ADDENDUM # 1

Project Name: Windy Hill Road Improvements at Richmond Branch

Subject: Pre submission Questions and Answers

Project ID: RIC-01 Status: Conceptual
 Project Name: Windy Hill LWC Project Type: Culvert Improvement

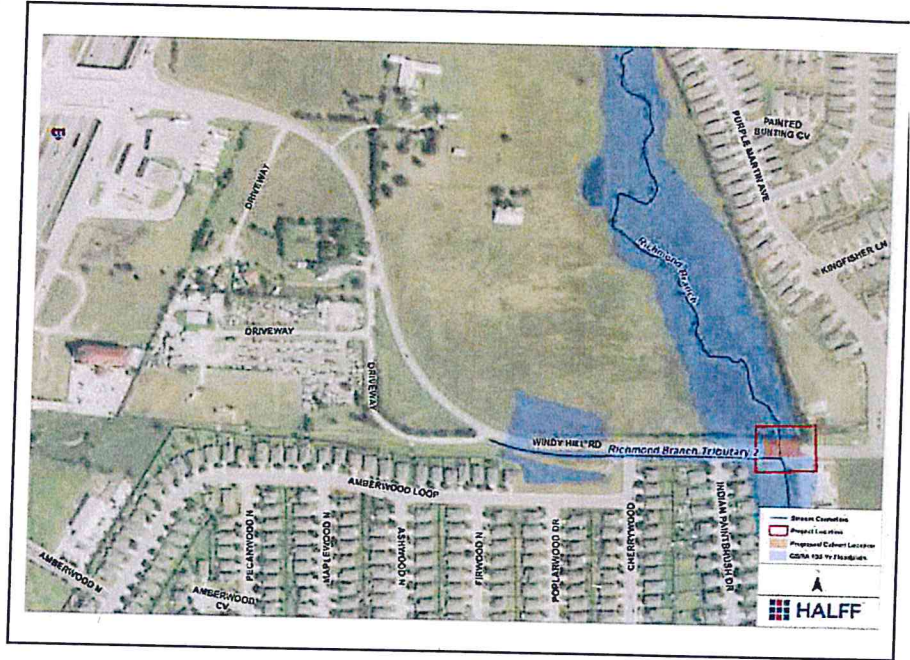
5) Can the proposed culvert sizes for the Richmond Branch Crossing identified in the DRAFT Drainage Master Plan be provided? If so, did this sizing take into consideration Atlas 14 data?

Low water crossing on Windy Hill Rd. The existing conditions indicate there are 2 - 7 ft. x 3 ft. box culverts under the roadway. The roadway crossing is overtopped by 0.5 ft. beginning with the 2-yr storm.

The City of Kyle Drainage Master Plan has not been accepted by City Council, therefore the report is not available on the City's website. Please see the following preliminary analysis pages from the City of Kyle Drainage Master Plan relevant to the Windy Hill questions.

Replace existing culverts with 5 - 10 ft. x 6 ft. box culverts to pass the 25-yr event. The 100-yr event will need a 60 ft. span bridge and raise the road 2 ft.
